**DOCUMENT - 2025-366T
HELIPORT RETROFIT IMPLEMENTATION AT 13653 MCLAUGHLIN ROAD,
CHELTENHAM, PEEL REGIONAL POLICE FACILITY
ADDENDUM 2**

Referring to the above Document 2025-366T - Heliport Retrofit Implementation at 13653 McLaughlin Road, Cheltenham, Peel Regional Police Facility, please note the following:

DISCIPLINE:		ELECTRICAL	
DRAFTER:	RJC	SCALE:	AS NOTED
DESIGNER:	RVG	DATE:	2025/02/21
APPROVER:	LC	CHECKER:	RVG
PROJECT No:	Z0022639	DRAWING No:	E-101
SHEET No:	6 of 11

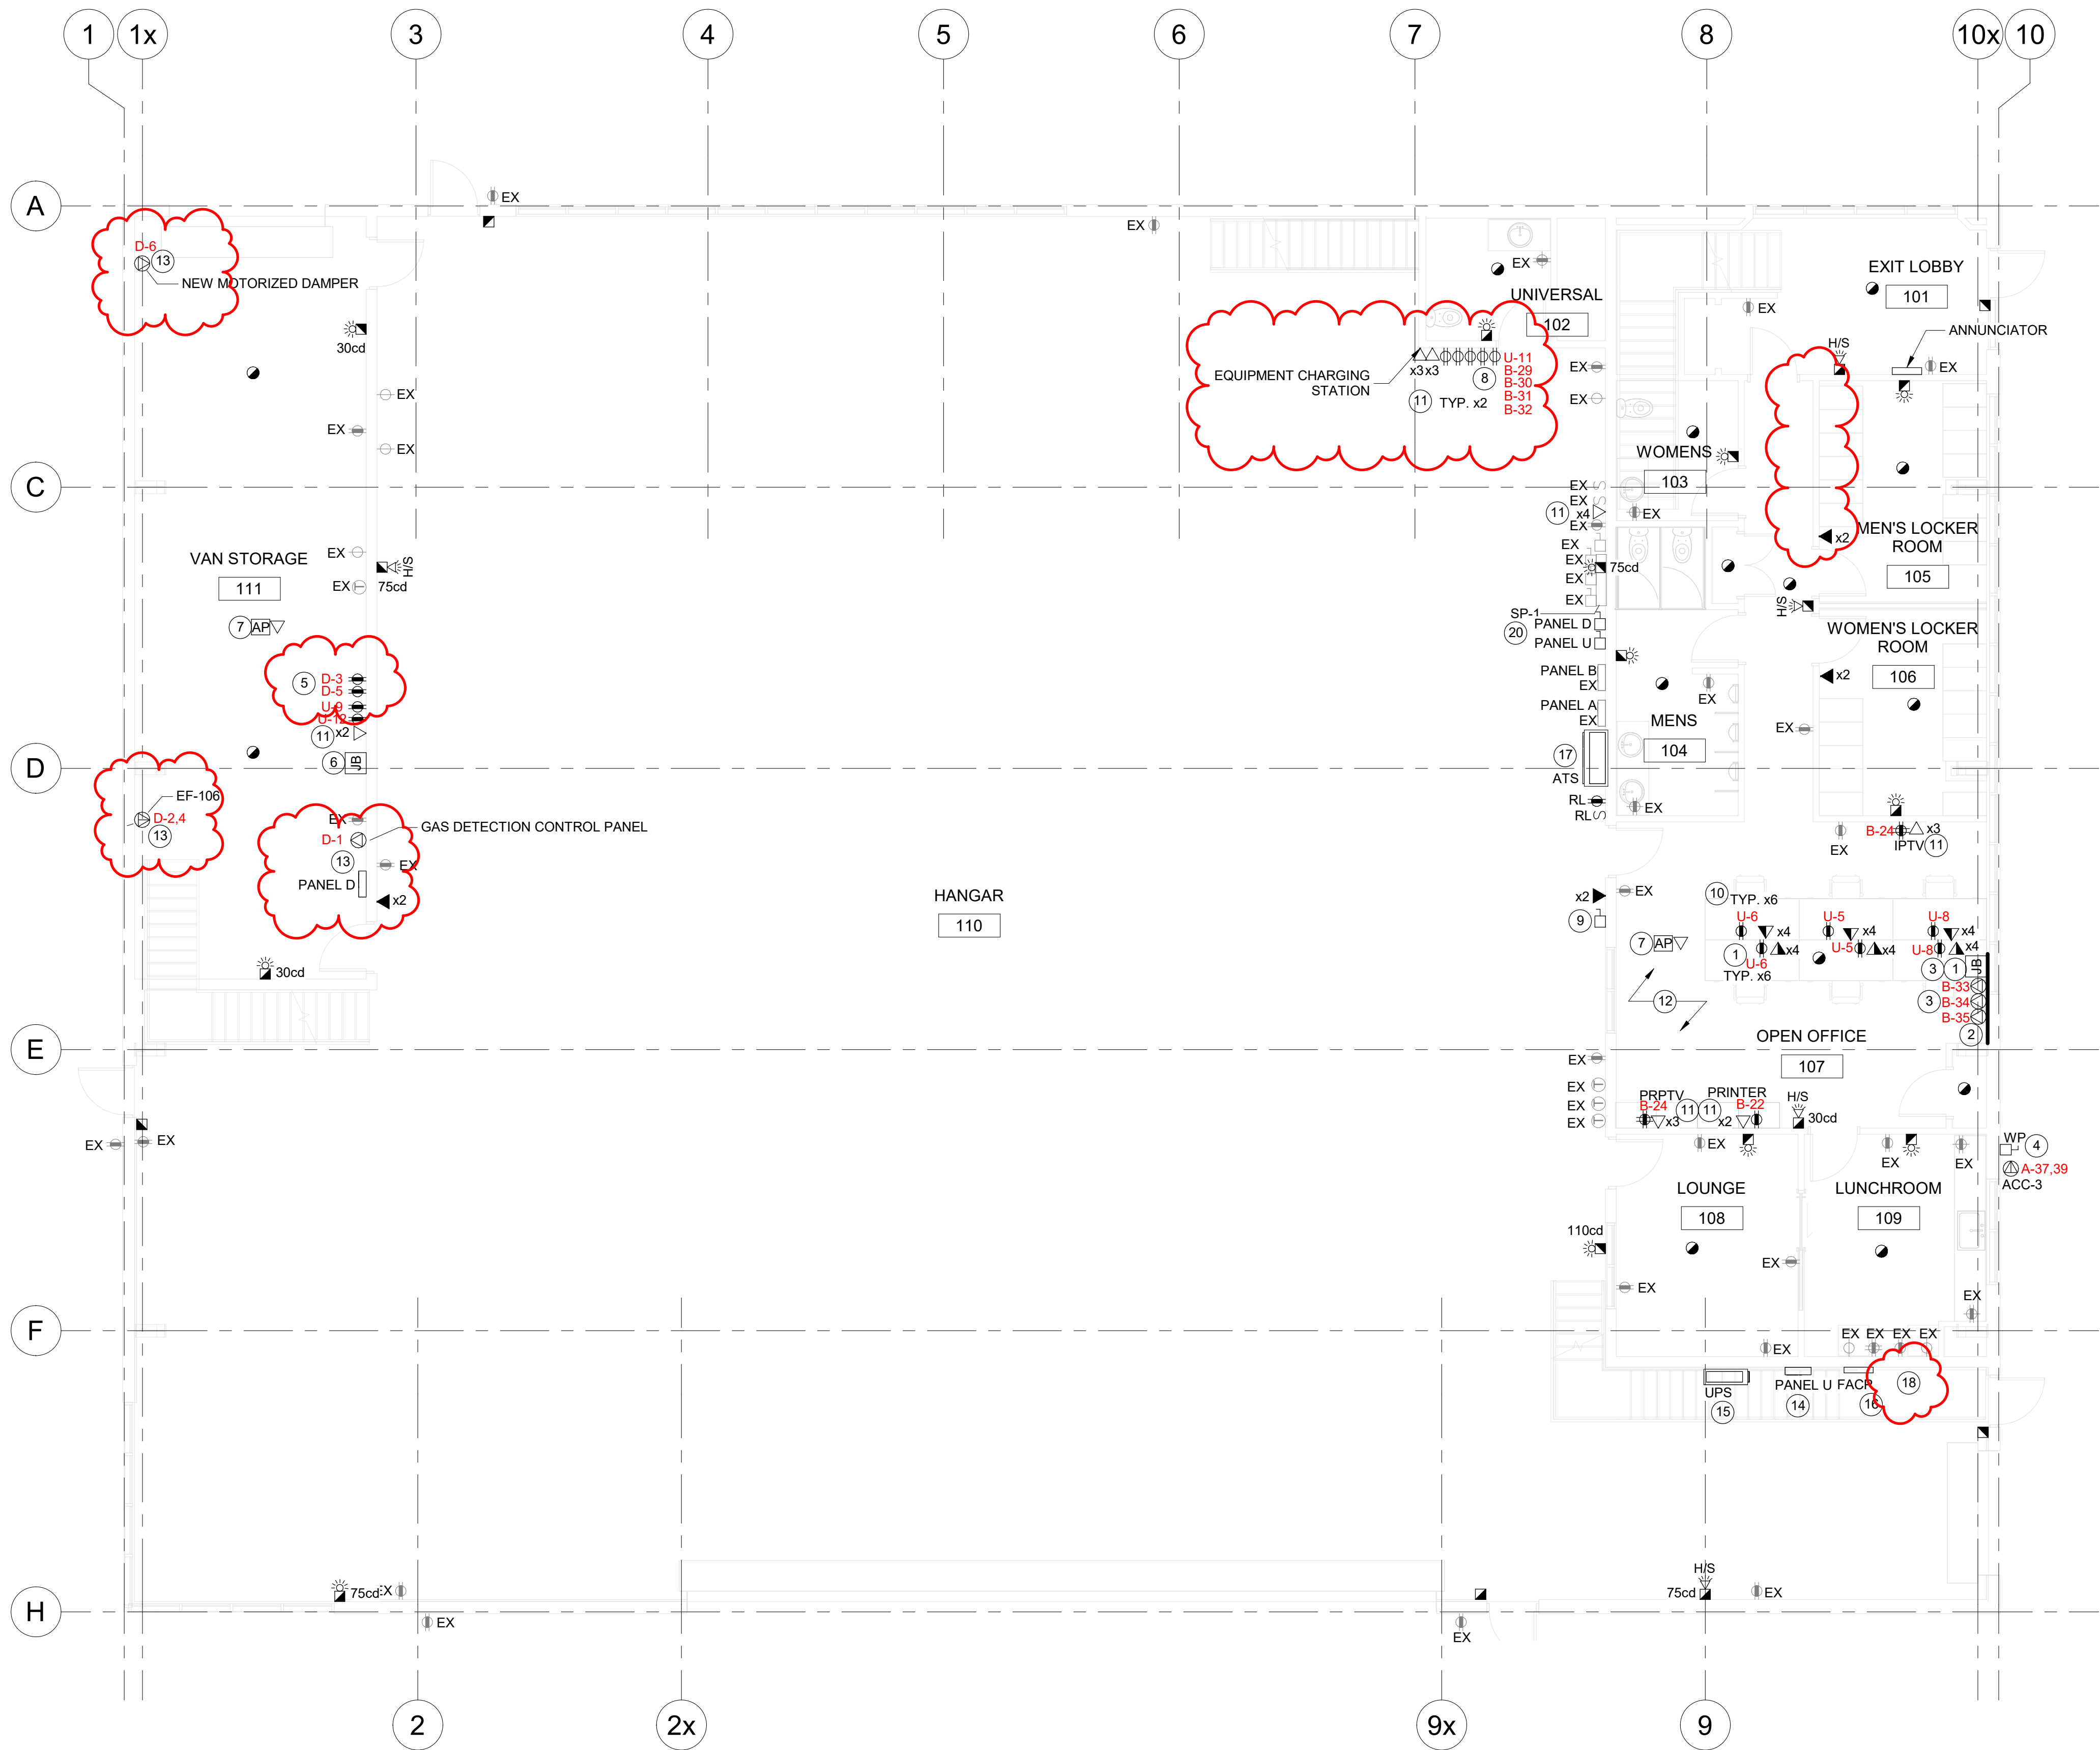
Drawing E-101 (see attached drawing for details)

- Clarified circuiting and labelling for new exhaust fan and damper
- Added new panelboard Panel 'D'
- Revised circuiting for devices in Van Storage area to be fed from Panel 'D' in lieu of Panel 'B'
- Added disconnects to plan for Panels 'U' and 'B'
- Revised location of Equipment Charging Station and associated devices
- Added alternate pricing for installation of Equipment Charging Station at alternate location. Refer to updated bidding form

On drawing E-101 Note 12 states to provide 7-foot patch cords quantity shall be total of data/voice ports in the entire project plus 10% spare. Is there a requirement to provide Line cords at the workstation end?

No.

DISCIPLINE:	ELECTRICAL	
DRAFTER:	RJC	SCALE: AS NOTED
DESIGNER:	RVG	DATE: 2025/02/21
APPROVER:	LC	CHECKER: RVG
PROJECT No:	Z0022639	DRAWING No:
SHEET No:	8 of 11	E-103

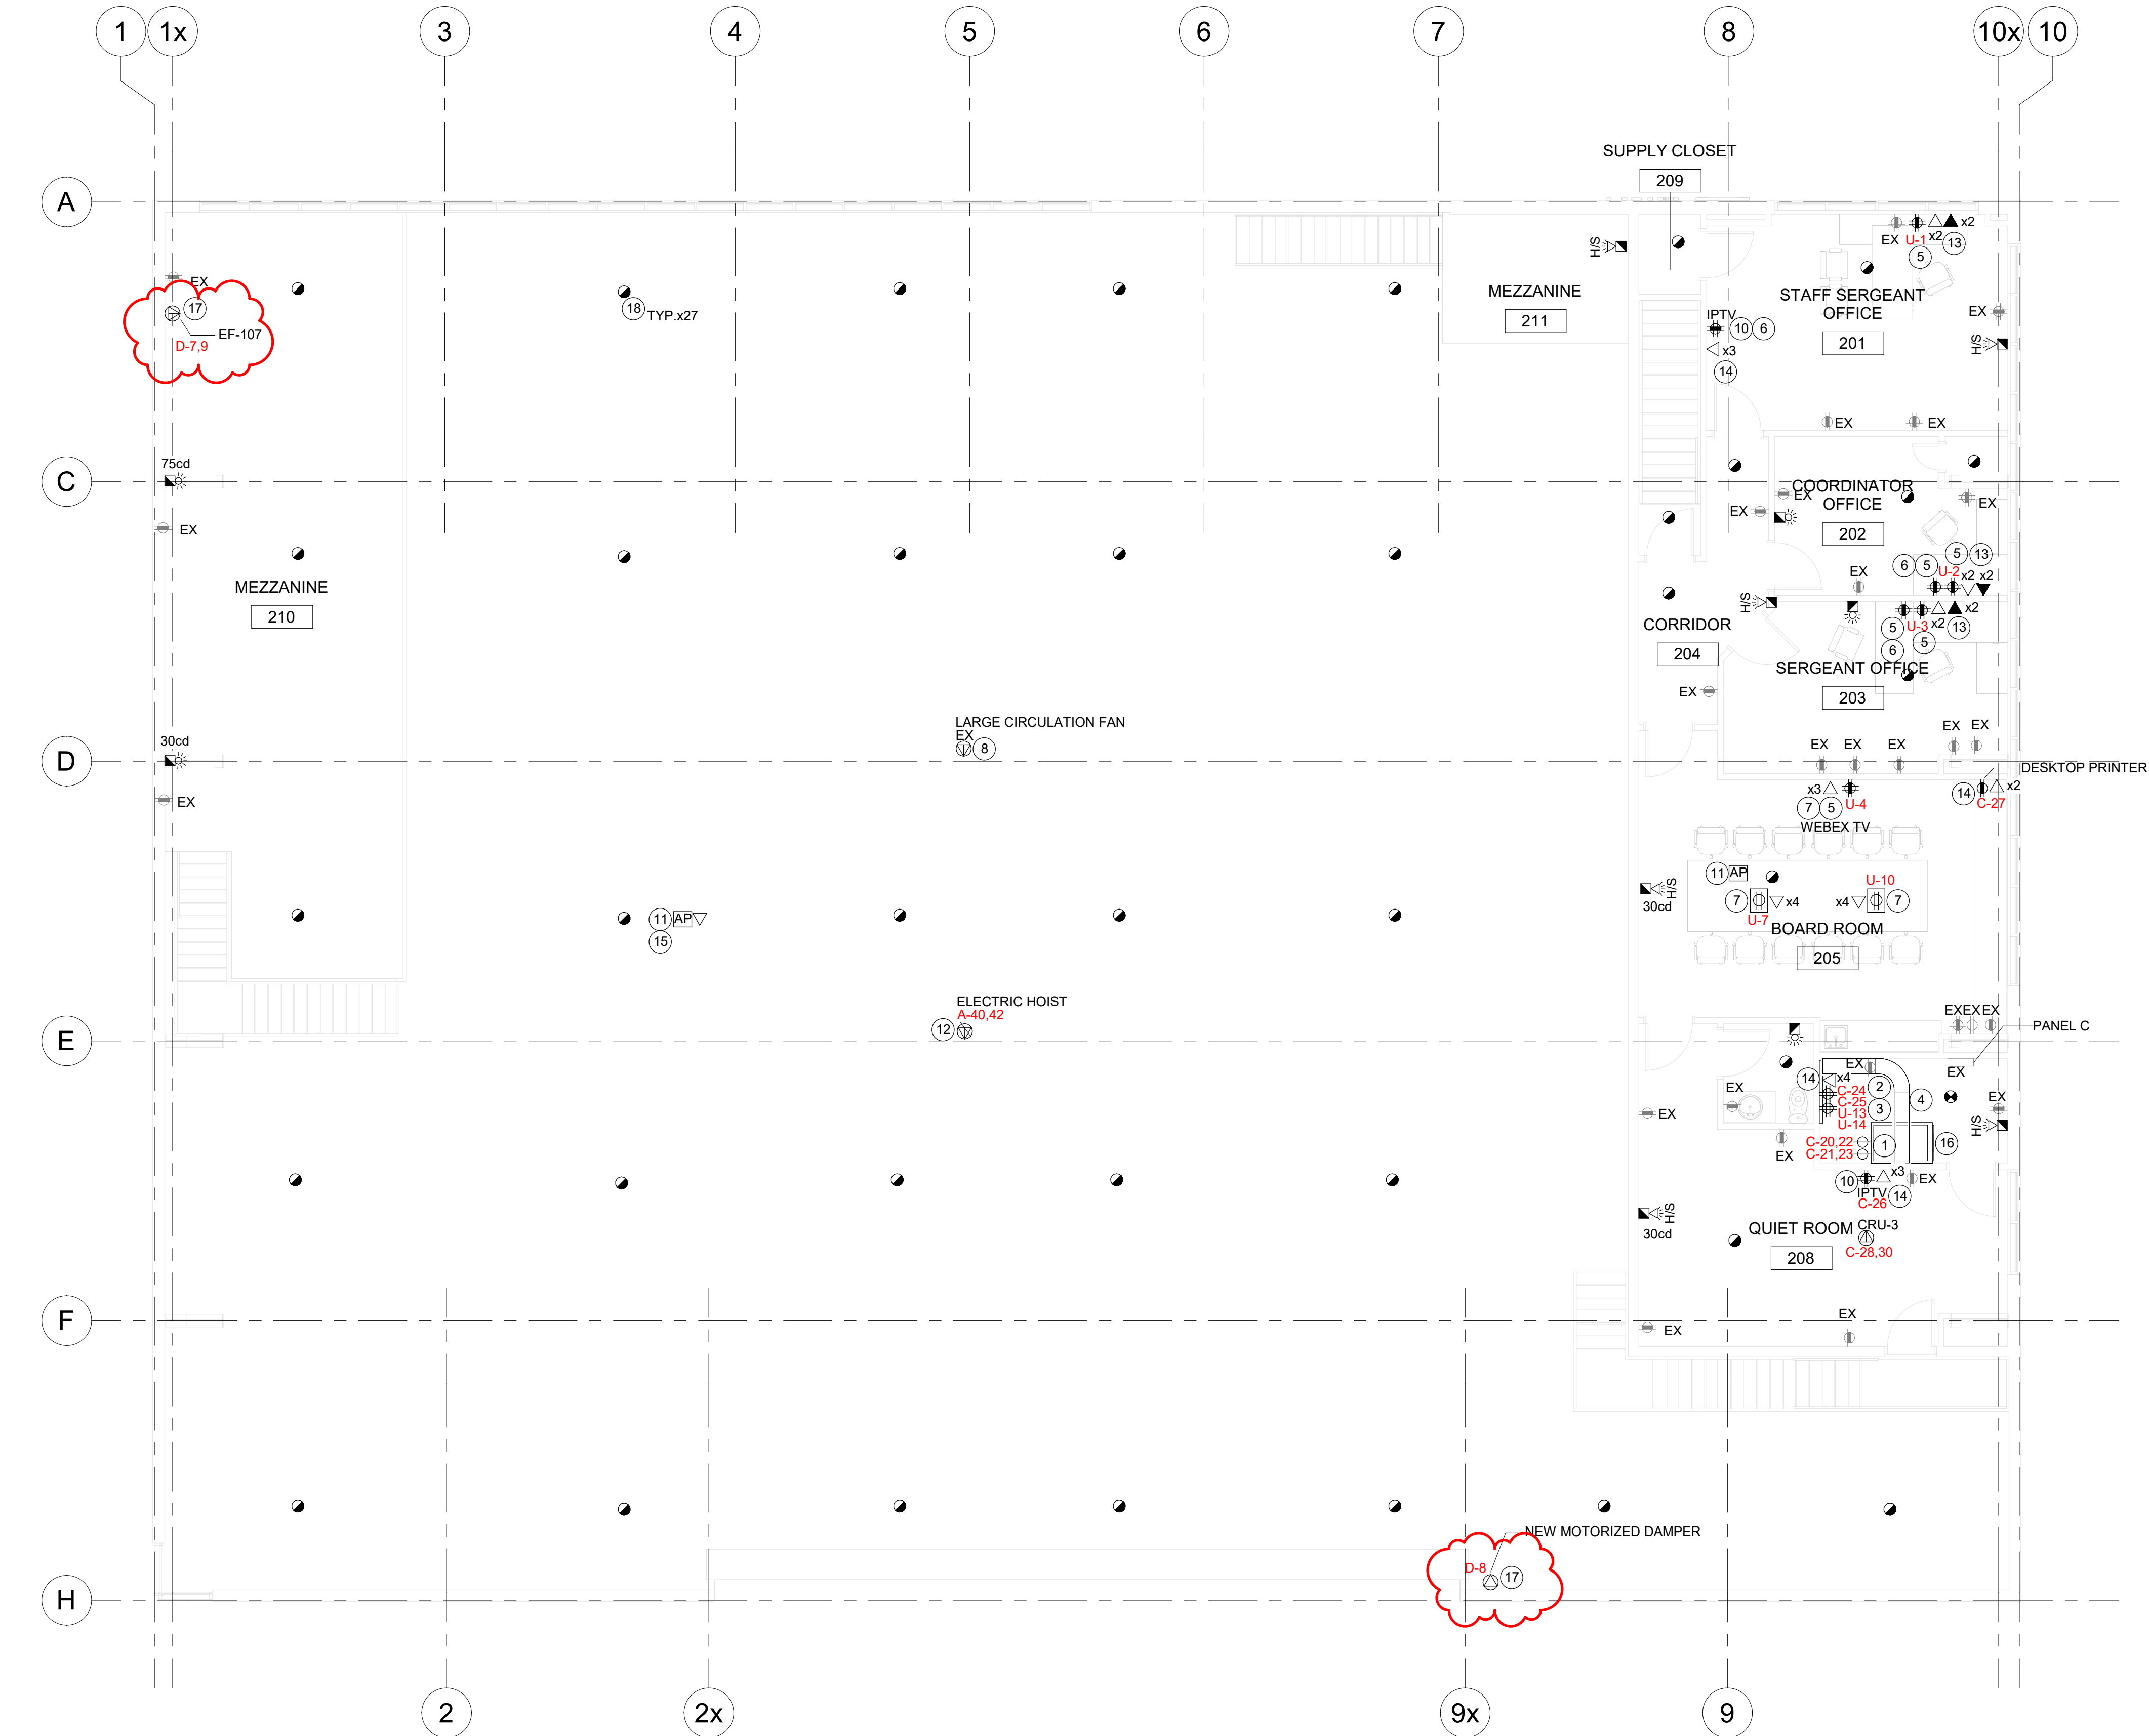
Drawing E-103 (see attached drawing for details)

- Clarified circuiting and labelling for new exhaust fan and motorized damper

Is the contractor to supply the rack or as per drawing E-103 note 16 Rack to be supplied by owner unless noted otherwise?

Contractor to provide patch panel as indicated on drawing and install in rack. Rack and other rack mounted equipment is supplied by owner and installed by this contractor.
